Garrisons Lake Boat Ramp Reconstruction
DFW Contract No. NAT20001-Garrisons

Addendum 2: Question Responses and Drawing Revisions

GARRISON'S LAKE BOAT RAMP RECONSTRUCTION

AS NOTED

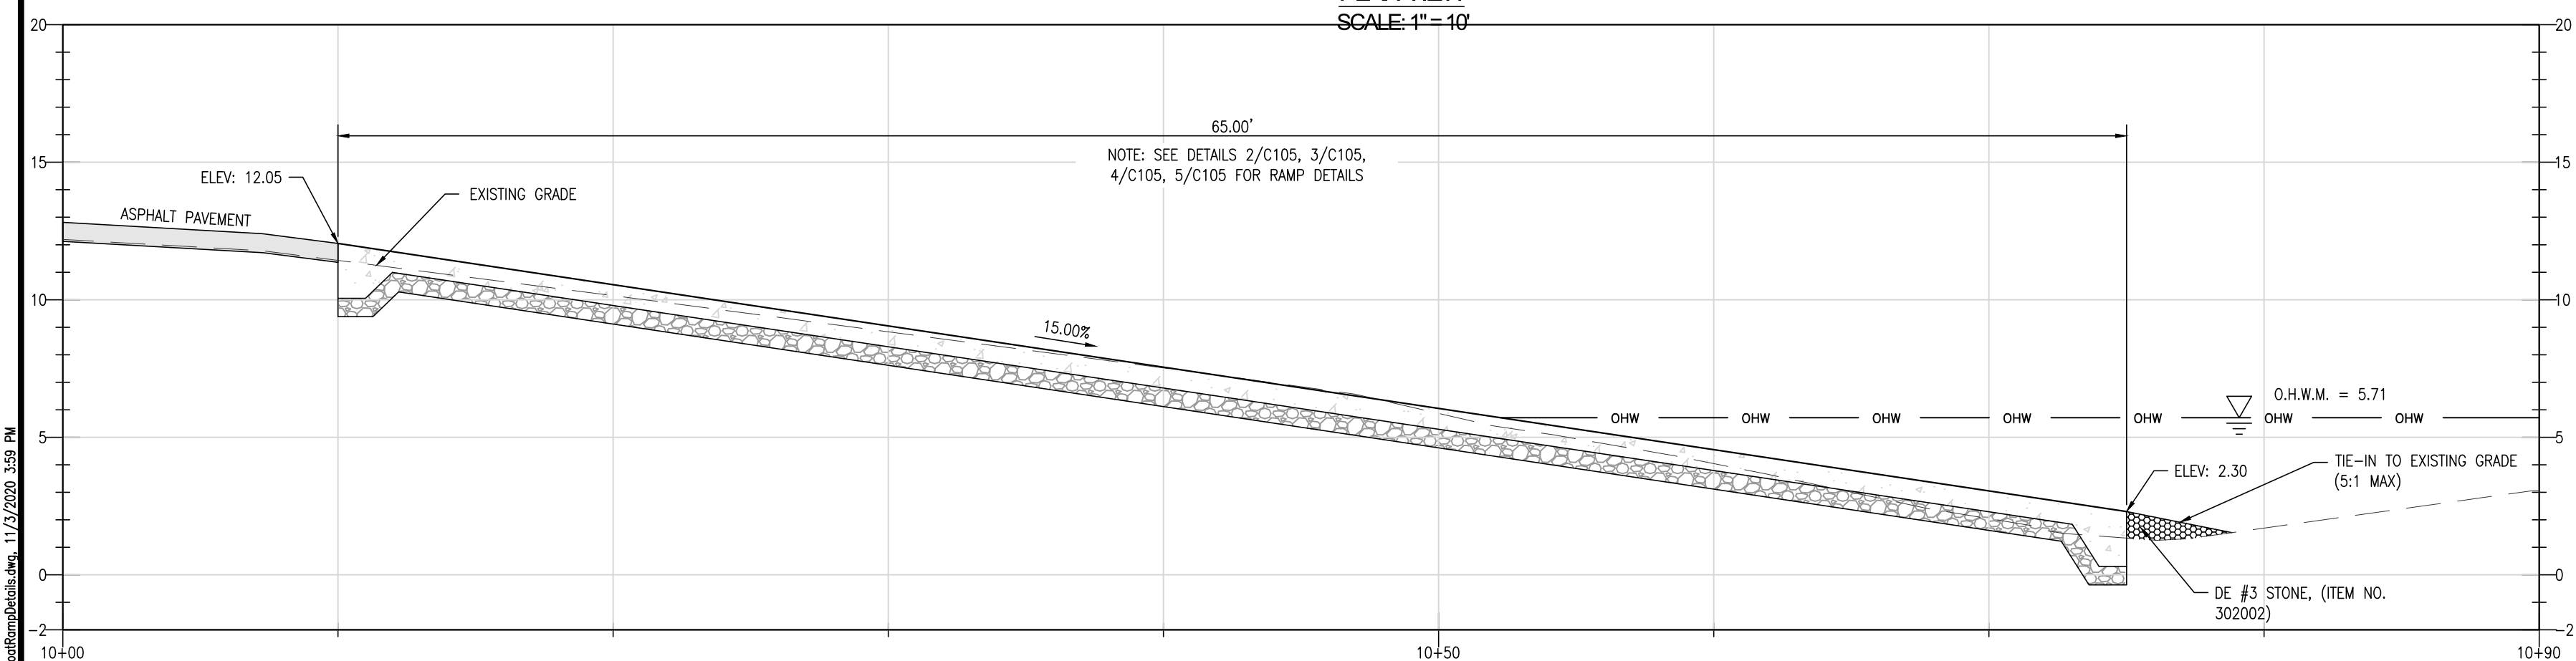
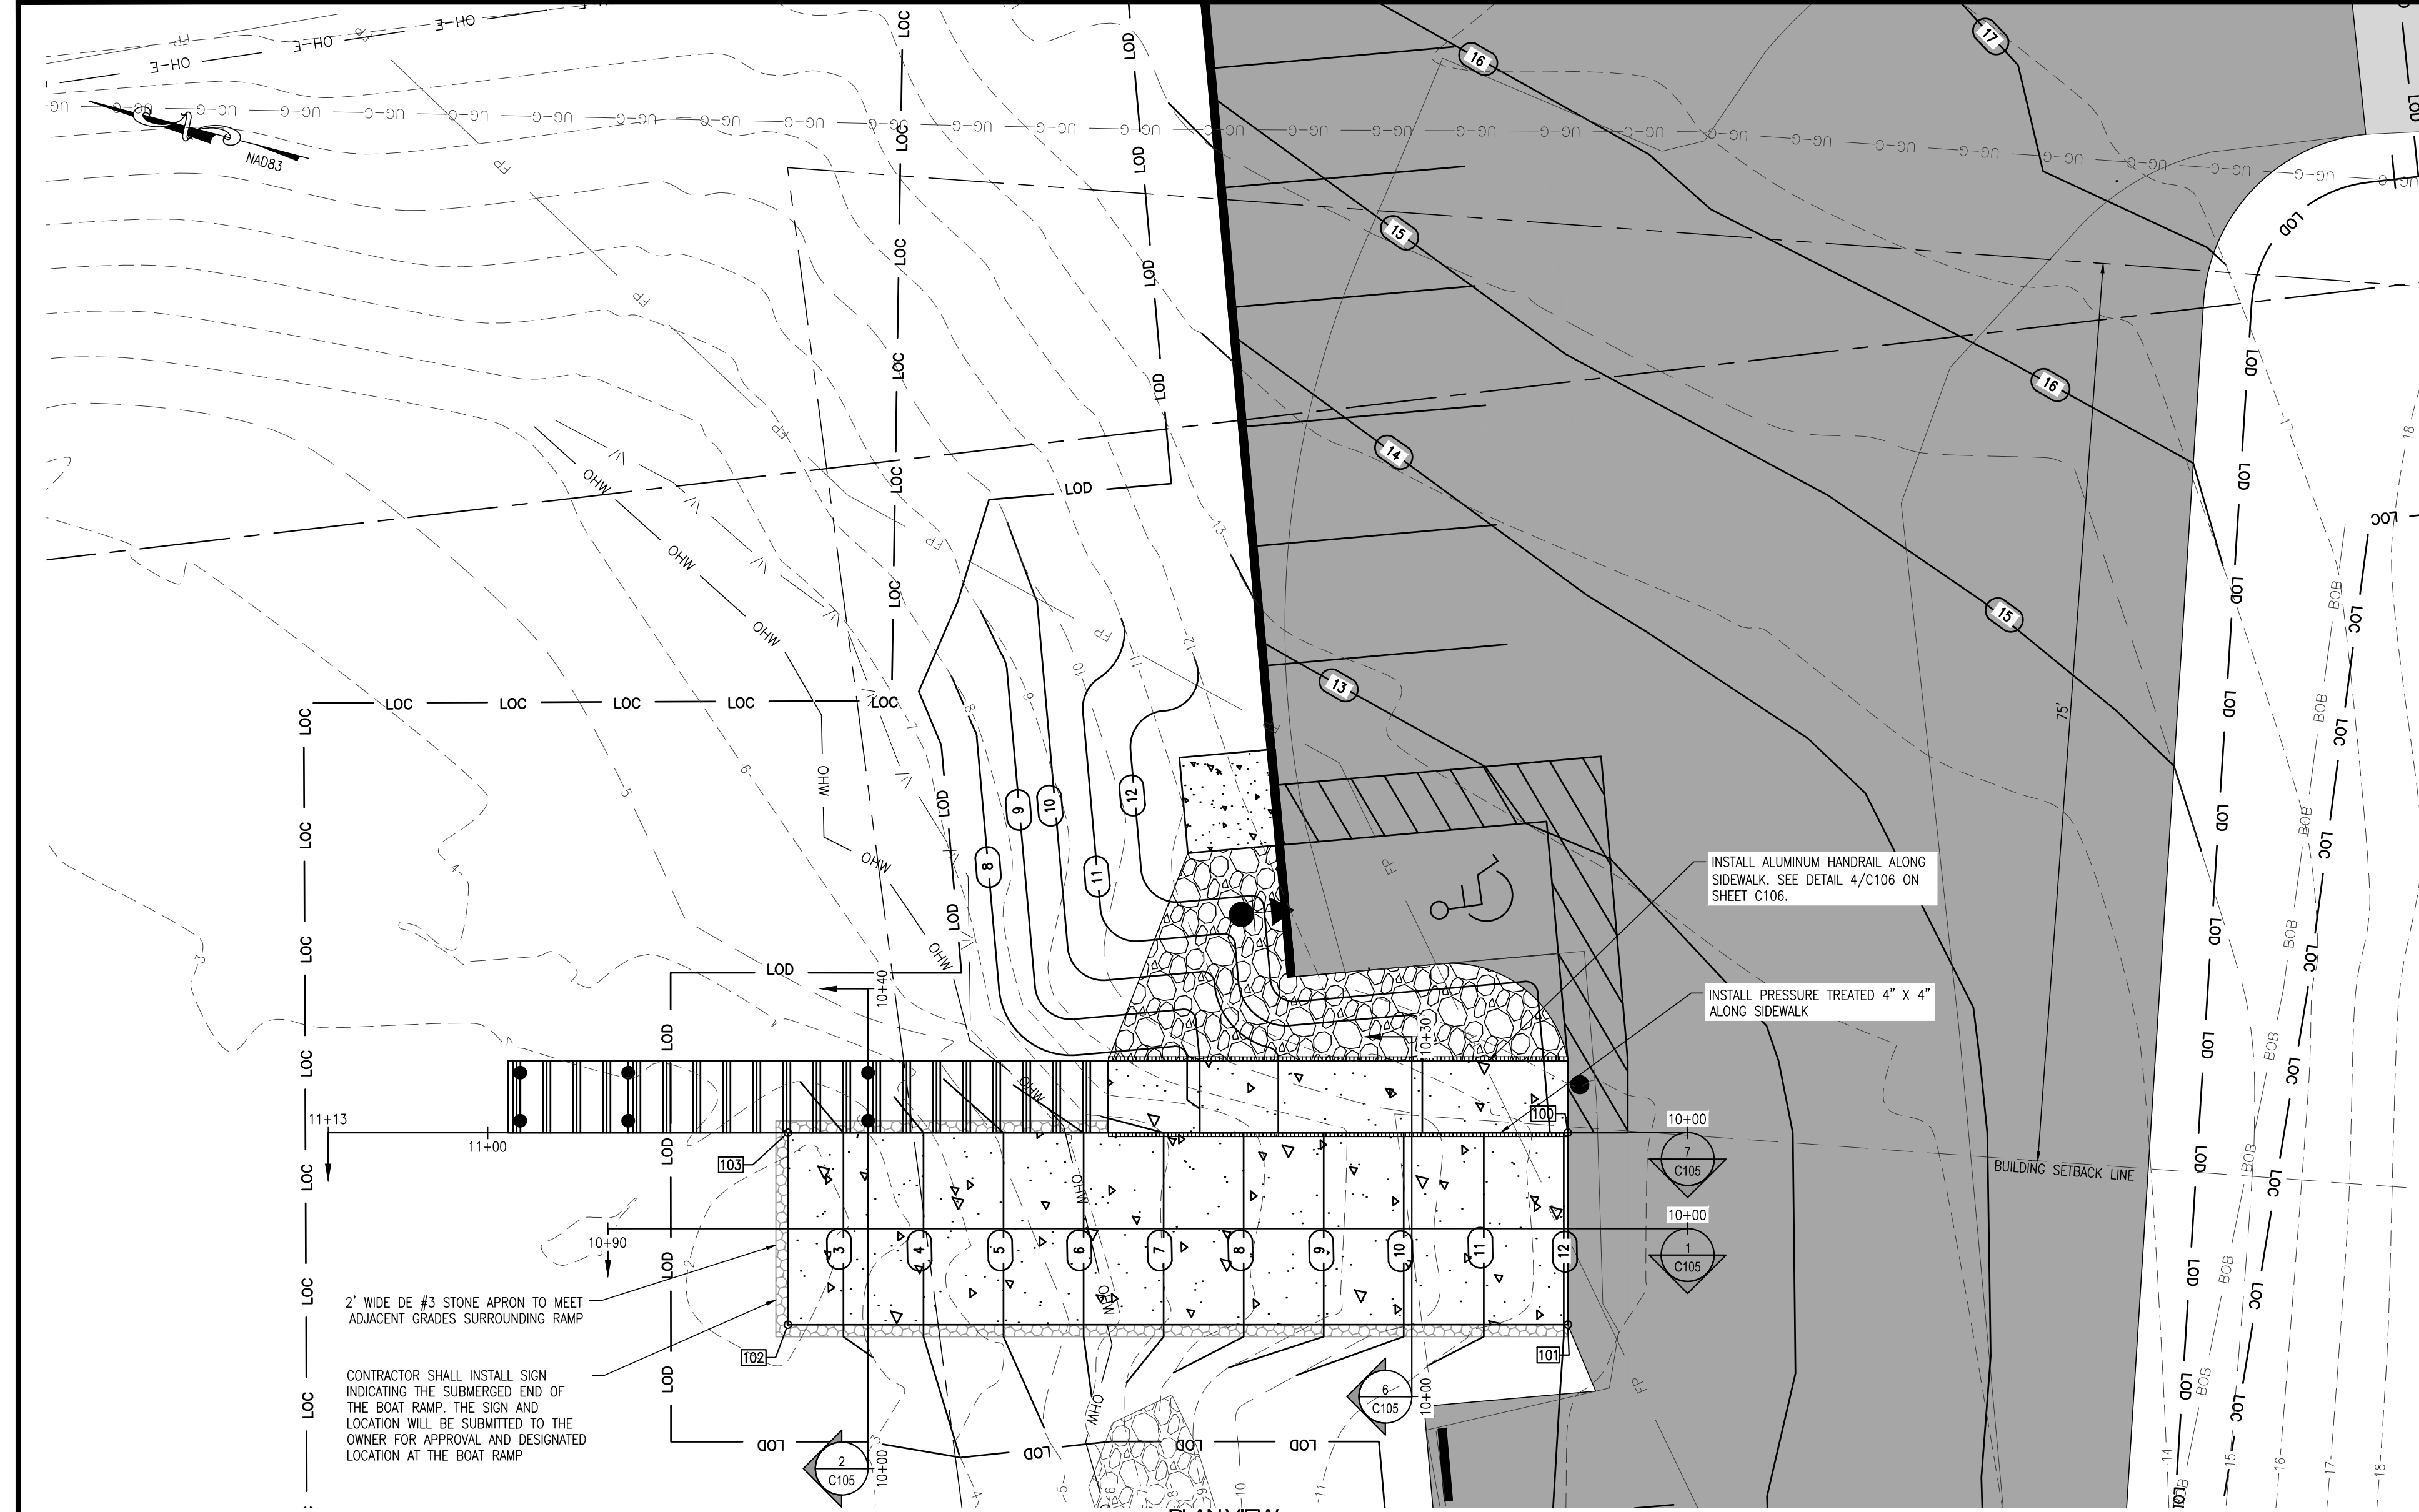
1. Section 6/C105 shows what appears to be vinyl D bumper on wood fenders mounted to each side of the sidewalk. Is this required on the sidewalk since it is above OHW elevation and one side is buried in riprap?

- a. RESPONSE: Bumper is to be placed on sidewalk to provide protection from trailers and vehicles.
2. Section 6/C105 shows 4" x 4" curbs at each edge of the sidewalk. The plan view on the same plan page shows aluminum handrail on the riprap side. Please clarify if you want the curb or handrail on the riprap side of the sidewalk.

- a. RESPONSE: Handrails are to be placed on rip-rap side. Handrail will be included in the GatorDock equipment/material provided by Division of Fish and Wildlife.

REVISIONS	
ADDENDUM	
DESCRIPTION	DATE
PROVIDED NEW DETAIL 6/C105, 11/03/2020
